SR 141/Bethelview Road @ SR 9 (Atlanta Highway) Intersection Improvements

CSSTP-0007-00(999), P.I. No. 0007999
Forsyth County, Georgia

Value Engineering Study Report

September 2009

ALT. NO.
ROW-3
Sht. 3 of 4

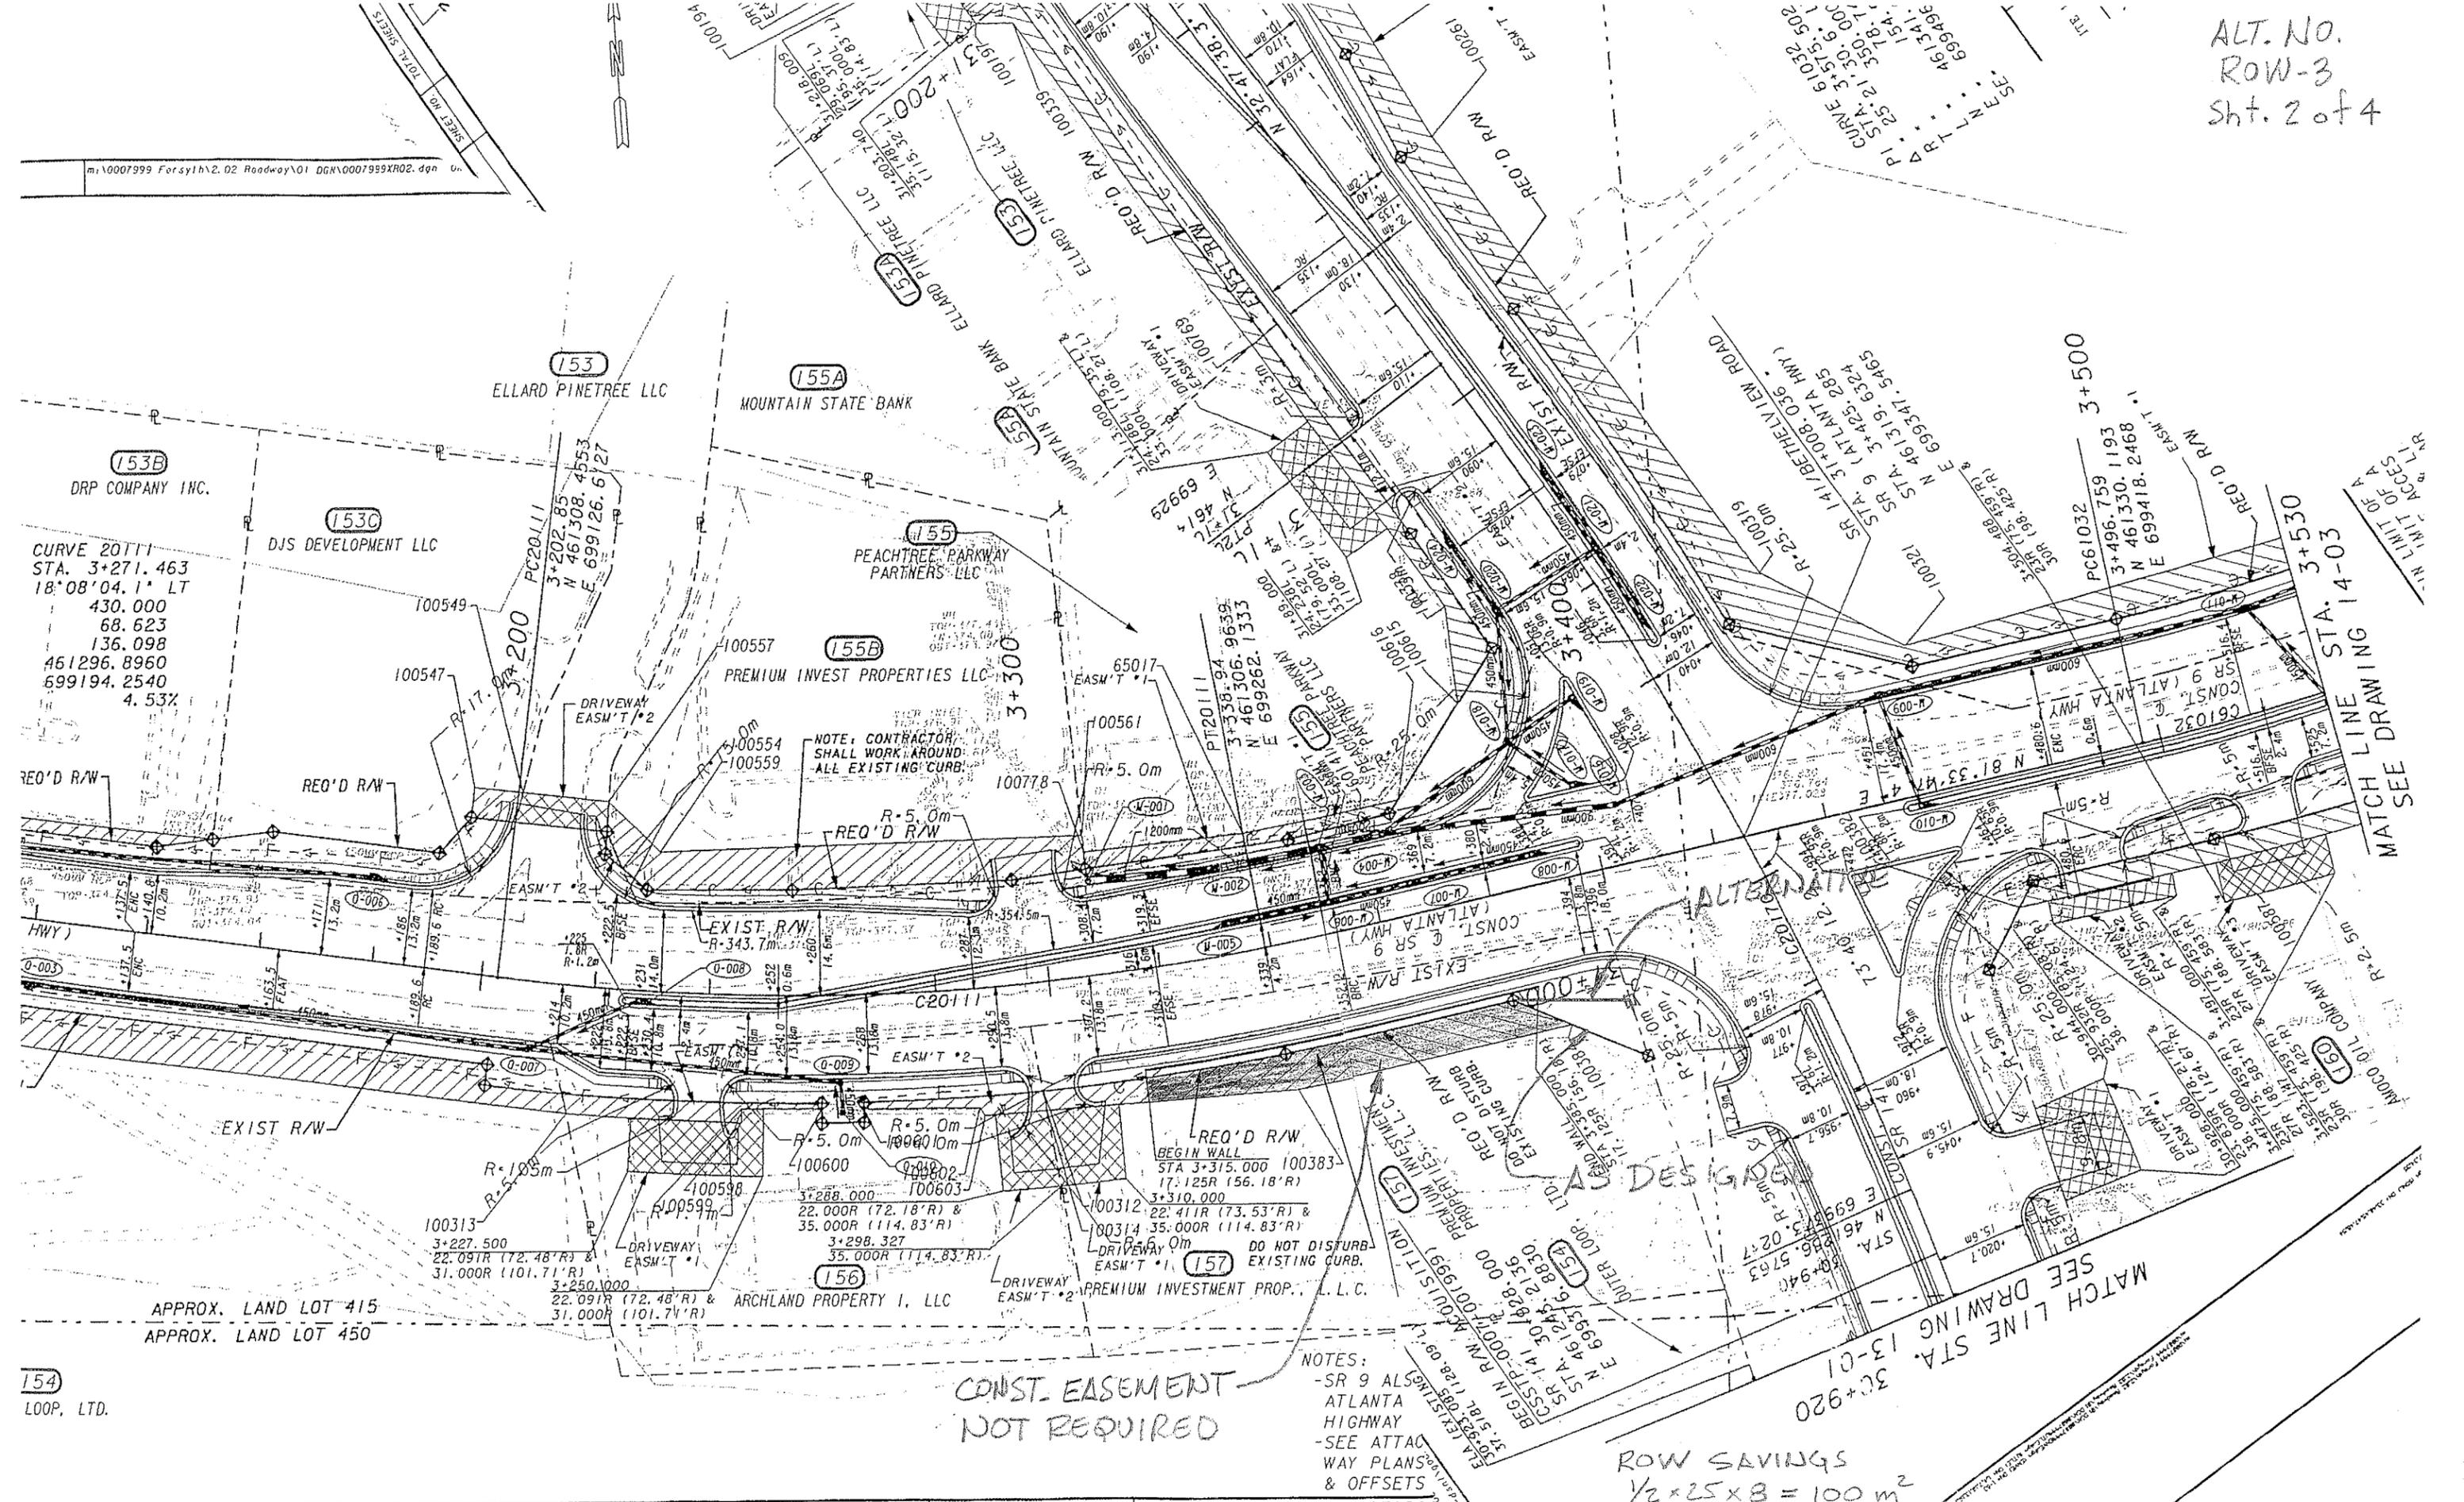
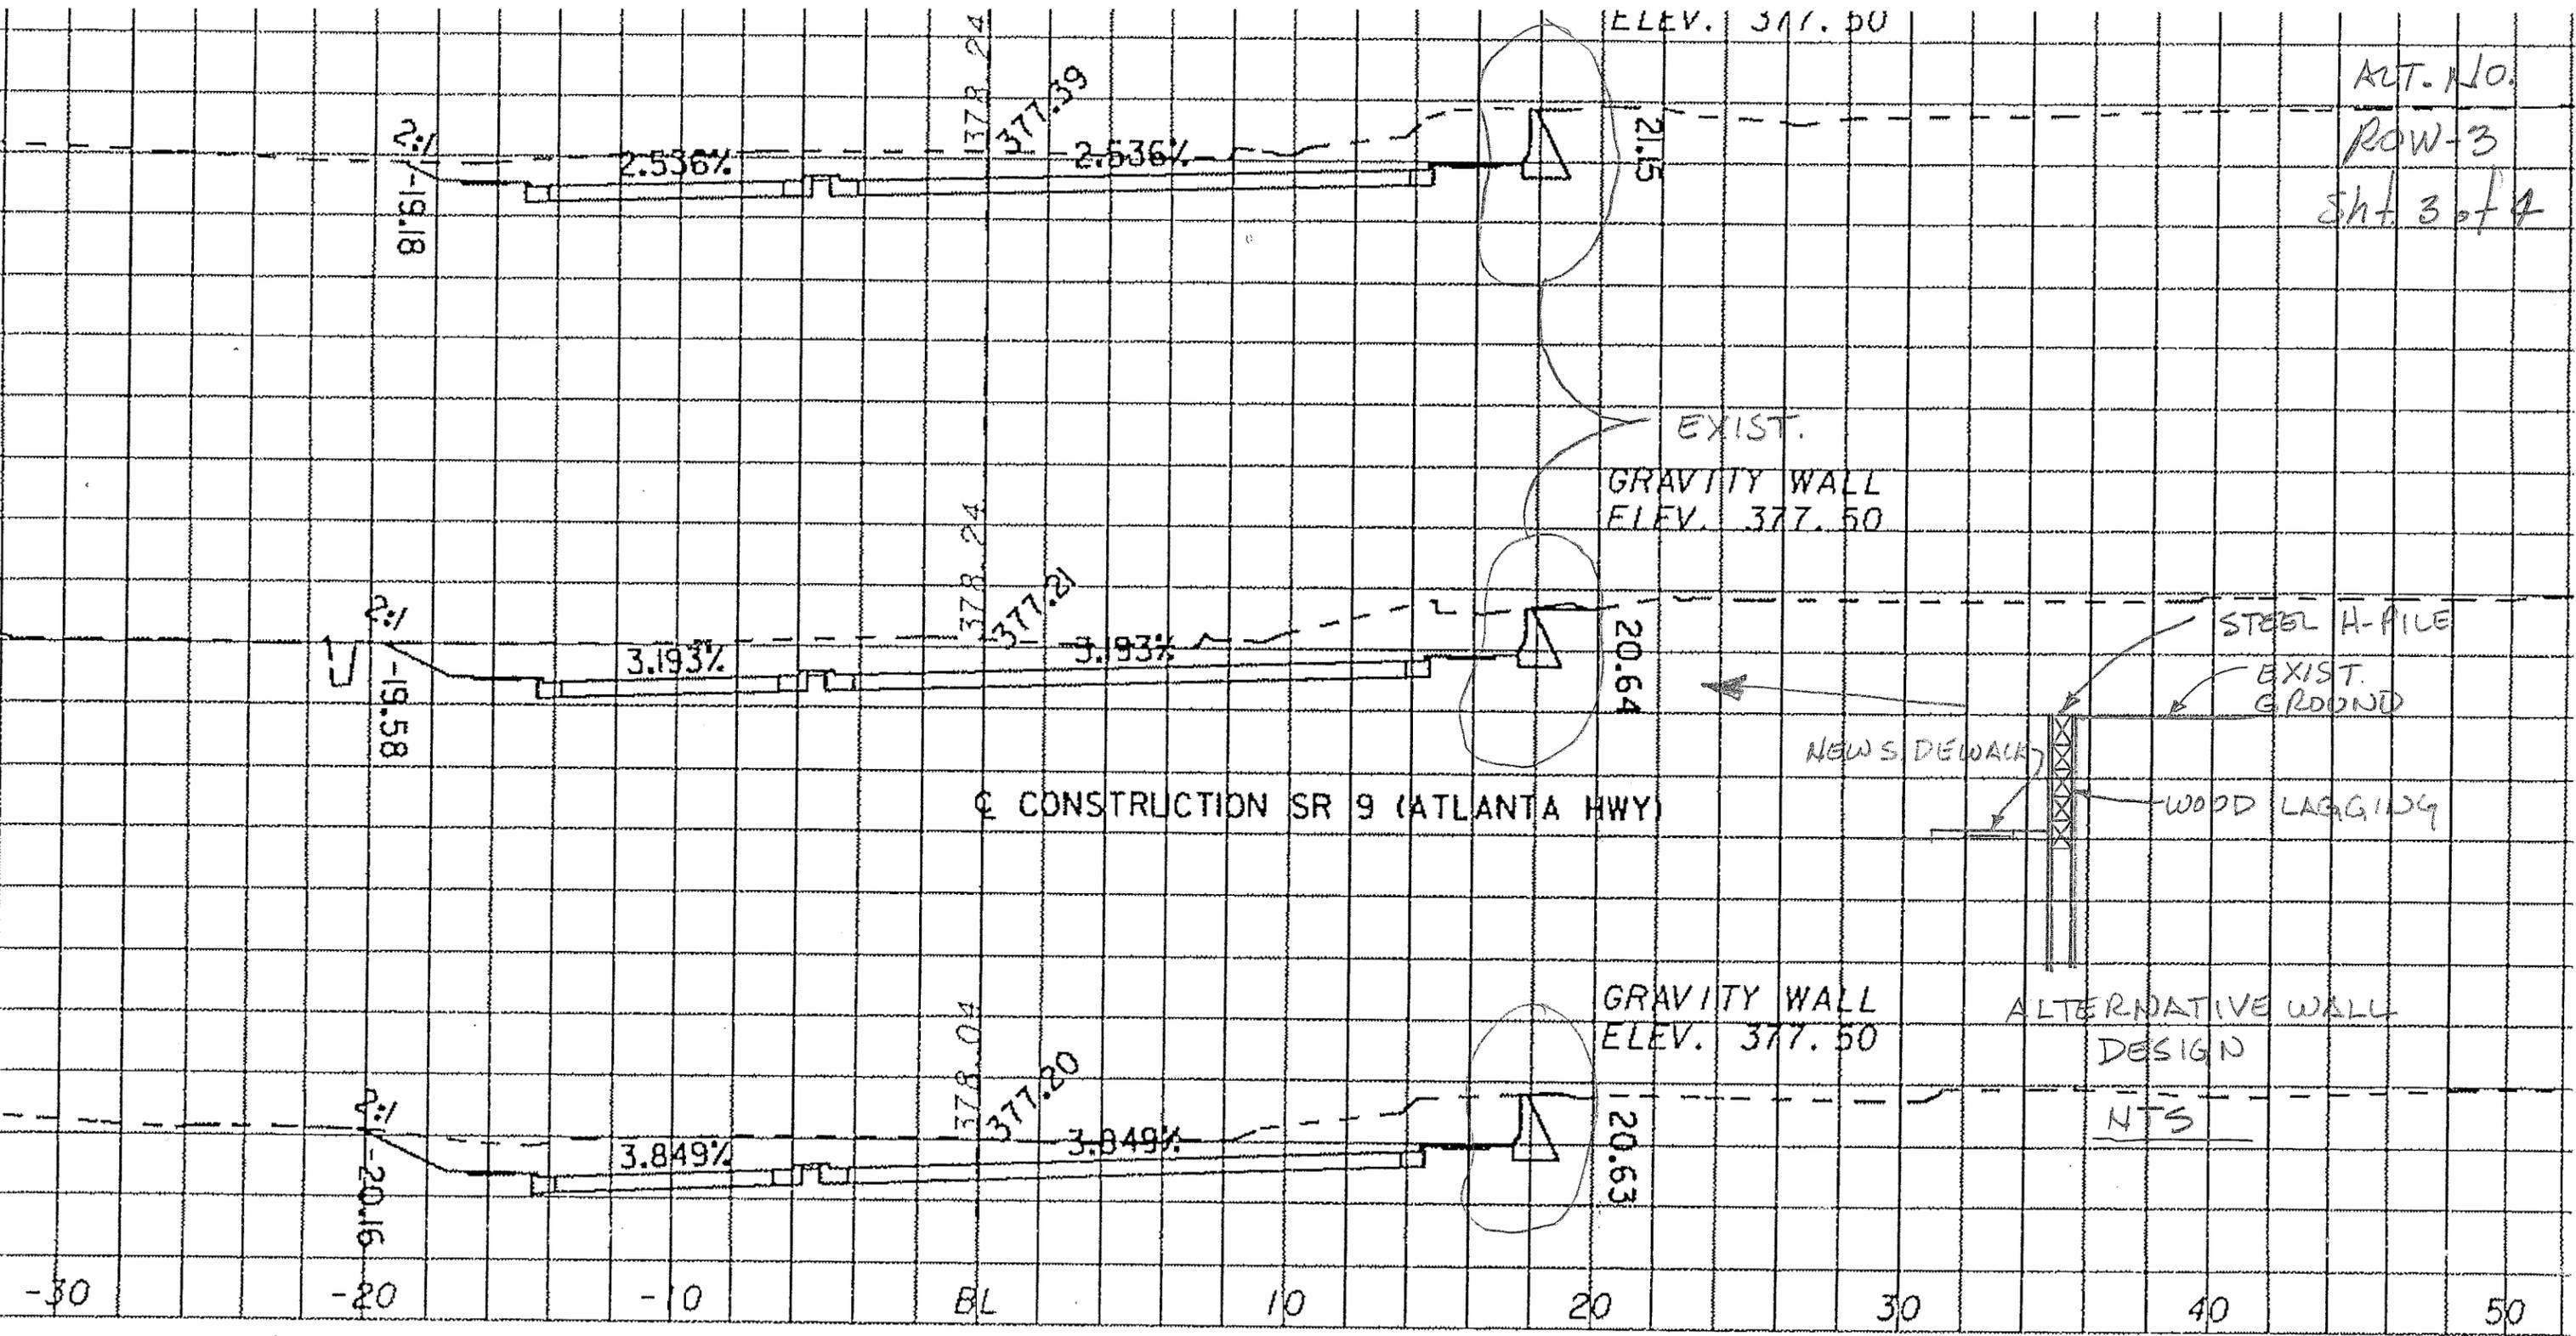
A concrete gravity type retaining wall is to be installed along the north side of Parcel 157, from Sta. 3+315 to Sta. 3+395, the Shell Gasoline Station, to protect an existing electrical utility transmission pole. This necessitates obtaining permanent right-of-way from the property owner and a temporary construction easement for constructing the retaining wall. The temporary construction easement necessitates eliminating some parking on the site during the construction. Also at the corner of the parcel at the intersection of SR 141 and SR 9, a triangular piece of right-of-way is being obtained. This impacts the existing sign at this location.

Use a cantilevered retaining wall with steel H-piles and either concrete or wood lagging to protect the existing electrical utility transmission pole and do not perform any construction beyond the wall. Revise the right-of-way acquisition line at the corner to avoid impacting the existing sign.

This alternative is designed to avoid the costly impacts to the gasoline station located on Parcel 157. By installing a retaining wall that requires no construction behind the wall, no current parking is affected by the construction and the temporary construction easement is not necessary.

ALT: P-1
 Sheet 3 of 4

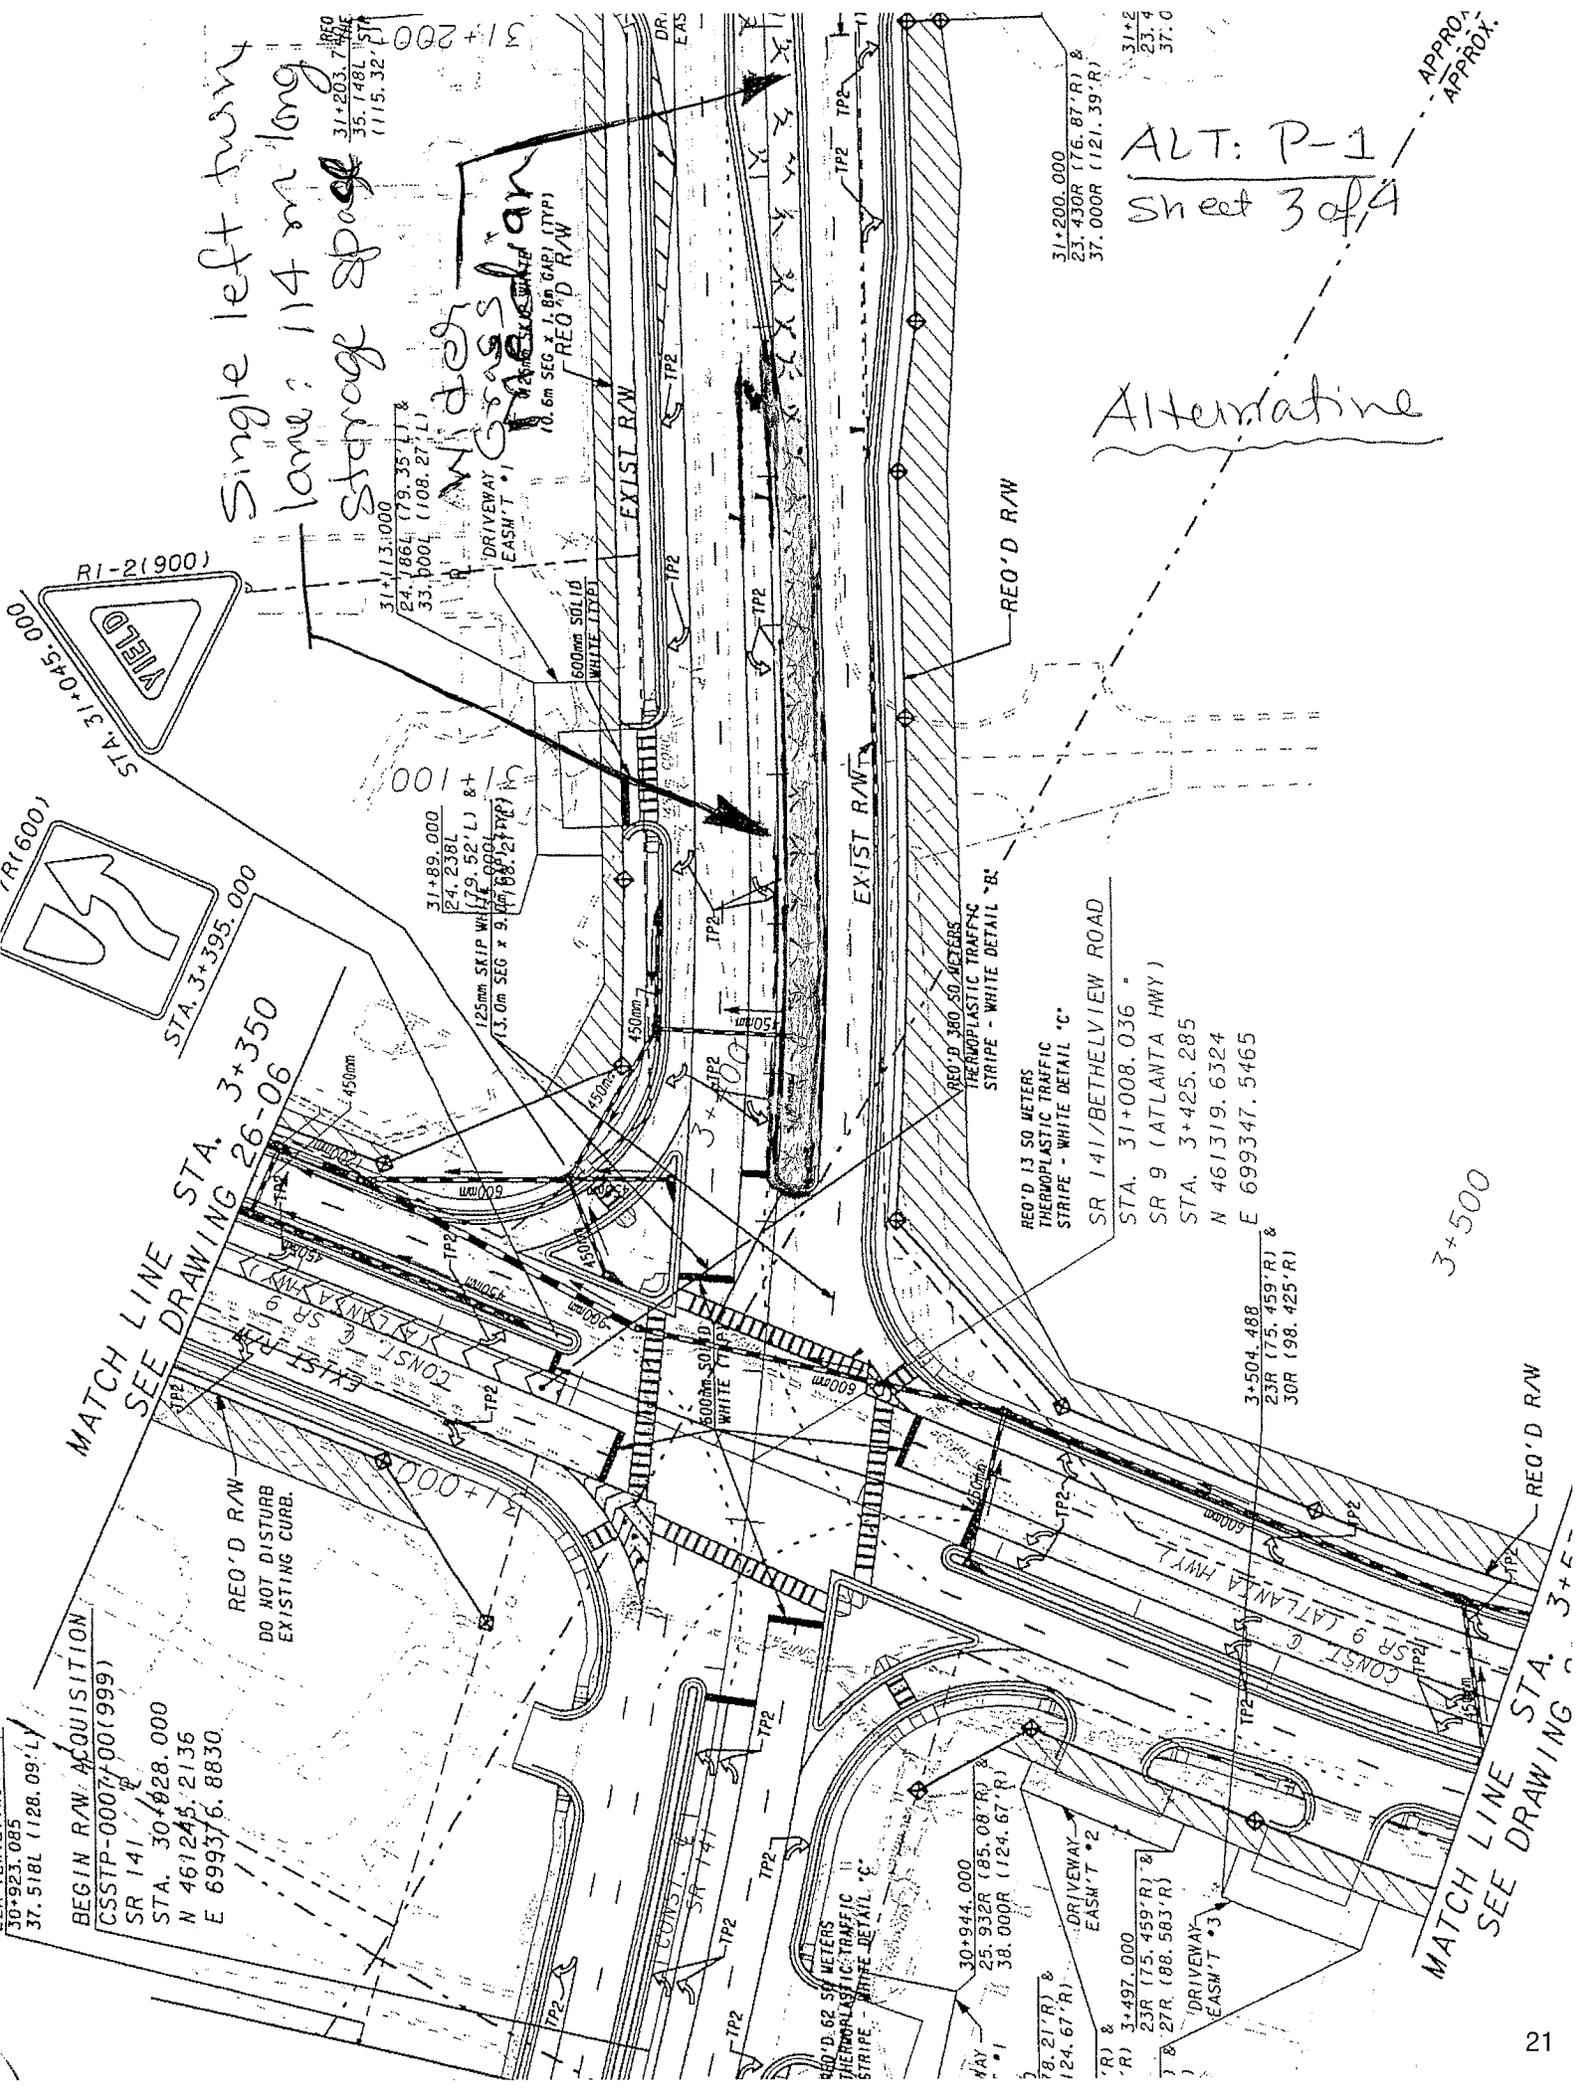
Provide two left turn lanes on southbound Bethelview Road at the SR 9 intersection.

Provide one left turn lane on southbound Bethelview Road and make the median wider.

The maximum daily hour volume (DHV) of traffic in the year 2032 during AM hours is expected to be 165 while during the PM hours it is expected to be no more than 215. The storage length of the proposed inside left turn lane (as designed) is 84 m – enough for at least 11 vehicles. By eliminating the inside lane, the storage length for the remaining left turn will be 114 m. This space will be able to store 15 vehicles. The signal timings will not be affected since the opposing direction will still have two left turn lanes with maximum traffic of 580 DHV in PM hours in year 2032.

Single left turn
 lane: 114 m long
 storage space
